Project	IEEE 802.16 Broadband Wireless Access Working Group < http://ieee802.org/16 >
Title	Amendment to Idle Mode Service Primitives
Date Submitted	2007-03-15
Source(s)	Jeehyeon Na, Jaesun Cha, JungMo Moon and Sangho Lee jhna@etri.re.kr ETRI 161 Gajeong-dong, Yuseong-gu Daejeon 305-700 Korea
Re:	Contribution on comments to IEEE 802.16g/D8
Abstract	Re-definition of Idle mode service primitives in section 14.2.4.2
Purpose	Adoption
Notice	This document has been prepared to assist IEEE 802.16. It is offered as a basis for discussion and is not binding on the contributing individual(s) or organization(s). The material in this document is subject to change in form and content after further study. The contributor(s) reserve(s) the right to add, amend or withdraw material contained herein.
Release	The contributor grants a free, irrevocable license to the IEEE to incorporate text contained in this contribution, and any modifications thereof, in the creation of an IEEE Standards publication; to copyright in the IEEE's name any IEEE Standards publication even though it may include portions of this contribution; and at the IEEE's sole discretion to permit others to reproduce in whole or in pa

Figure 479—Subscriber mode transition diagram at NCMS (on BS or MS side)

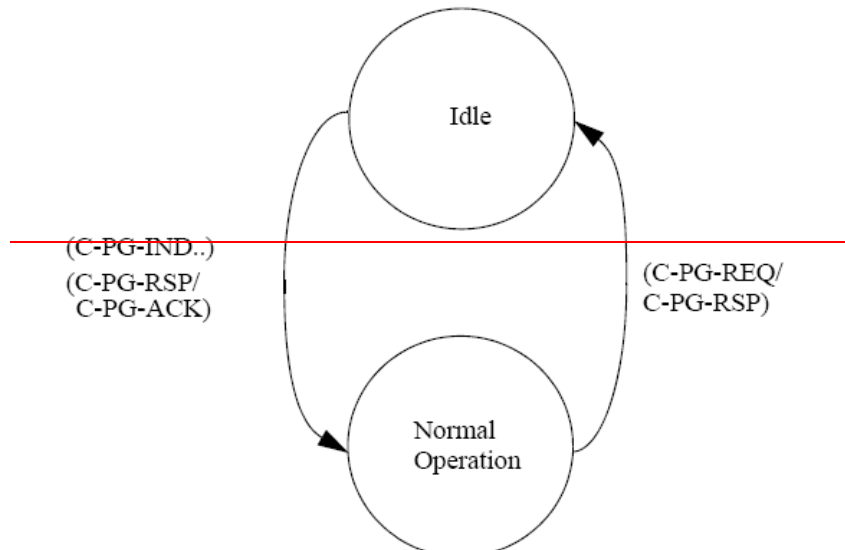
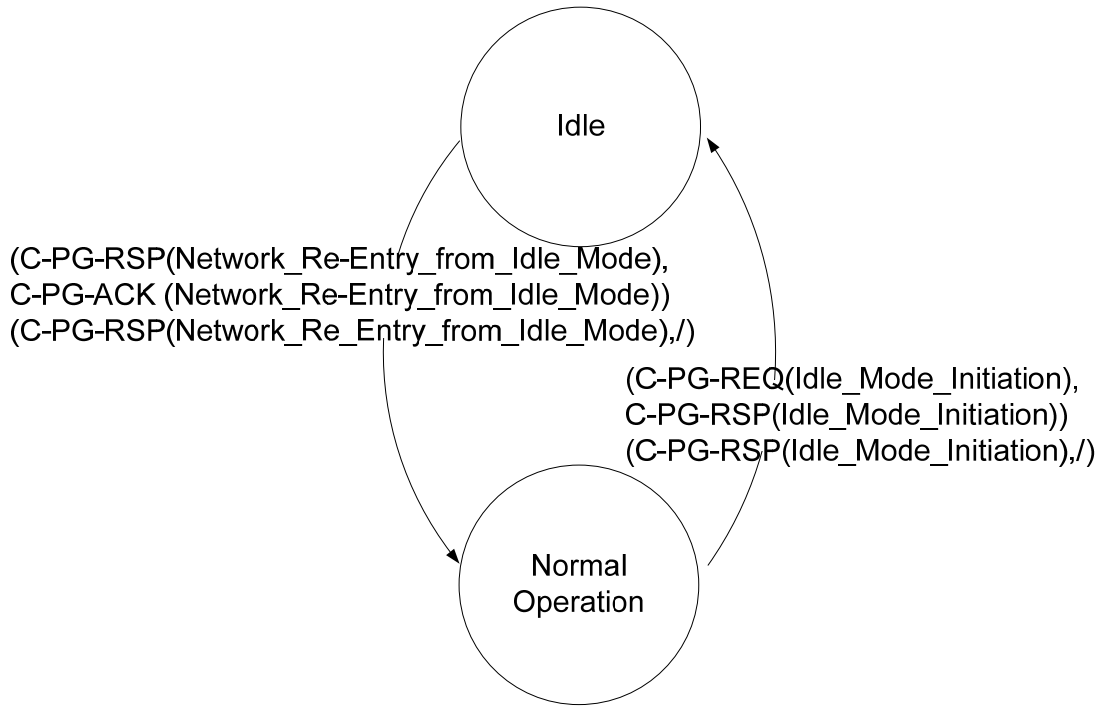
Subscriber mode management is described as informative in section 14.2.4 and it is managed at an MS, a BS and an NCMS. Figure 479 which shows subscriber mode transition diagram at an NCMS is not clear whether for an NCMS on a BS and an MS side or not.

Therefore, we clarify figure 479 and the related texts in order to be used both NCMS at an MS and a BS side.

Figure 479 shows Subscriber Mode transition diagram at the NCMS with service primitives related with the Subscriber Mode transition. Subscriber Mode transition from Normal Operation to Idle Mode is performed by exchanging C-PG-REQ and C-PG-RSP between ~~a BS~~ an 802.16 entity and the NCMS after successful DREG-REQ message from the MS with De-Registration_Request_Code=0x01 or DREG-CMD message from the BS with Action Code = 0x05, where C-PG-REQ and C-PG-RSP are defined in 14.2.4.2.1 and 14.2.4.2.2, respectively. Subscriber Mode transition from Idle Mode to Normal Operation is initiated after exchanging ~~C-PG-IND, C-PG-RSP,~~ and C-PG-ACK between an 802.16 entity ~~a BS~~ and the NCMS, where ~~C-PG-IND,~~ C-PG-RSP, and C-PG-ACK are defined in ~~14.2.4.2.4,~~ 14.2.4.2.2, and 14.2.4.2.3, respectively.

Figure 480 – Idle mode initiation (NCMS on the MS side)

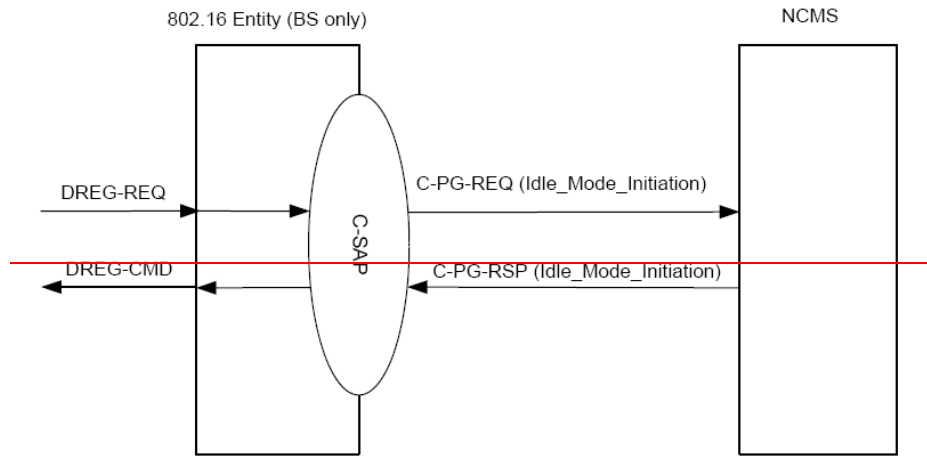
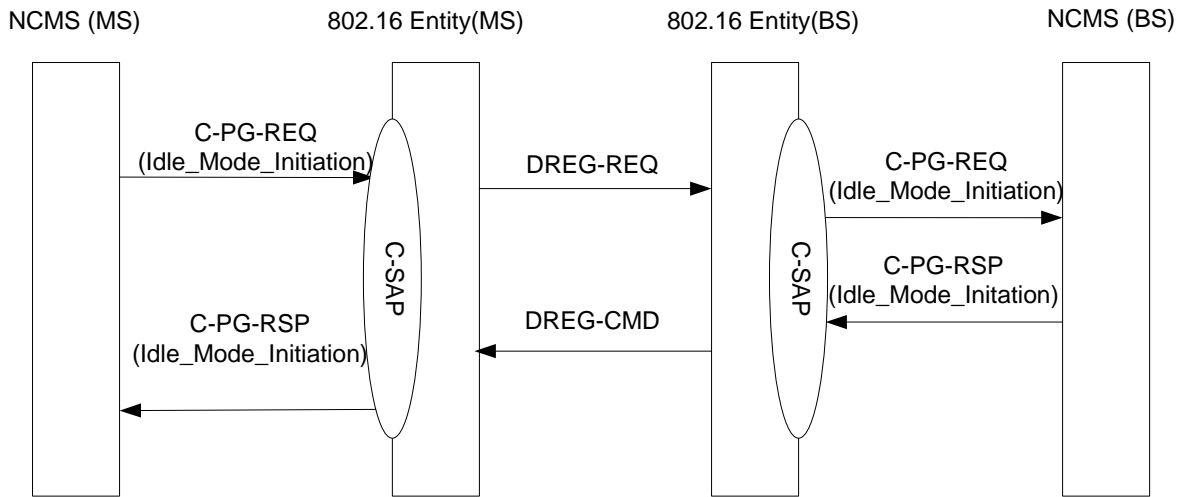
Therefore, we propose to change figure 480, 482, 483 to the figures which are included the service primitives between an 802.16 entity (MS) and an NCMS on the MS side and modify the related service primitives parameters in this contribution. And we also correct some editorial texts.

[Change the figure 480 and its title to as follows]

Figure 482- Paging Announce

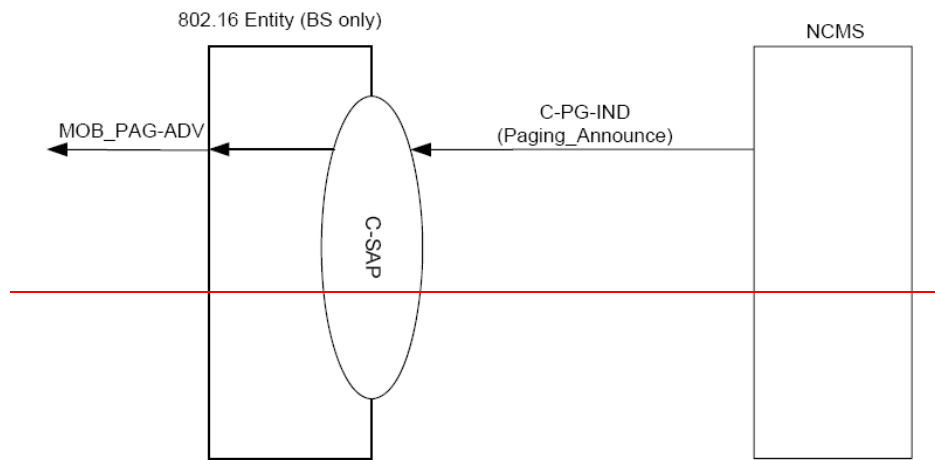
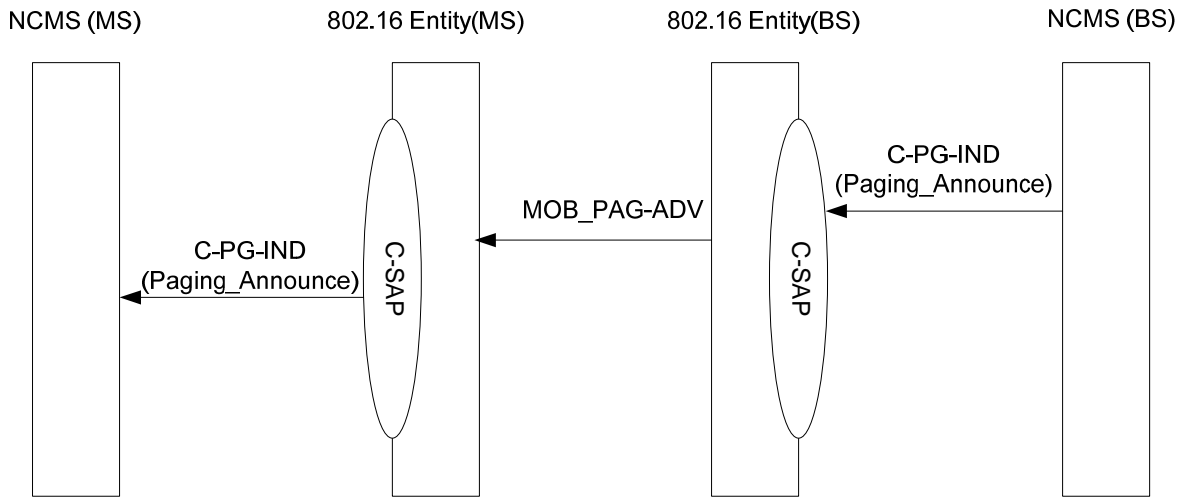
[Change the figure 482 to the following figure Section 14.2.4.2]

Figure 483- Network re-entry from Idle mode primitives

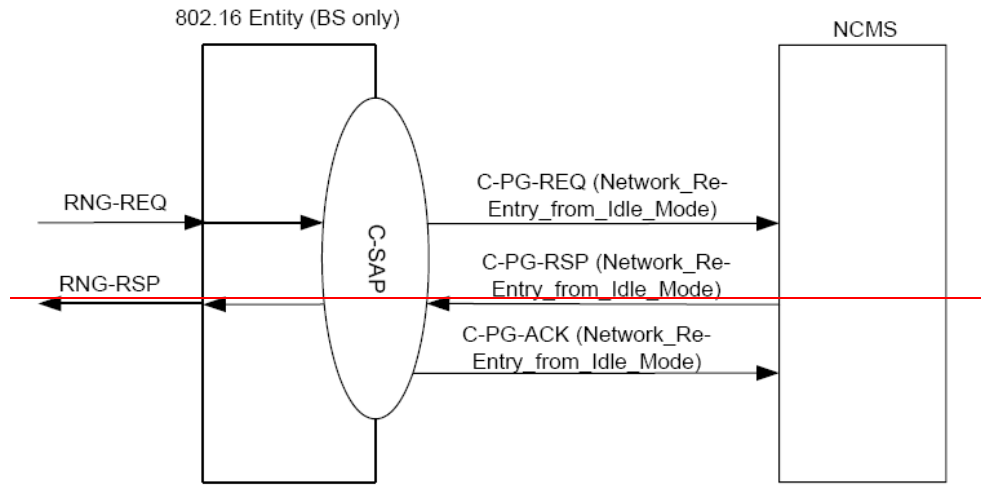
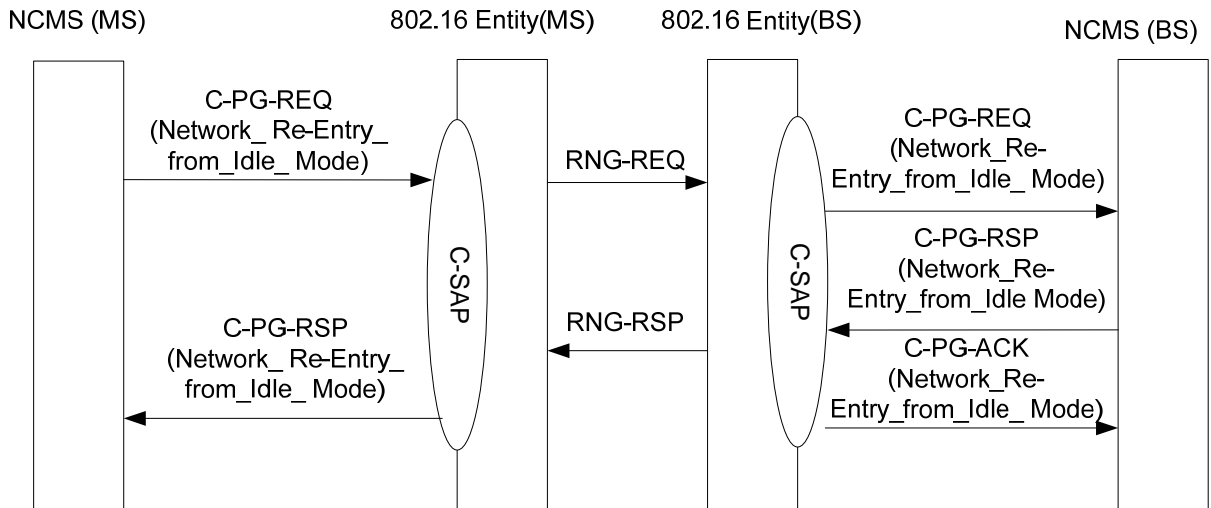
[Change the figure 483 to the following figure in 14.2.4.2]
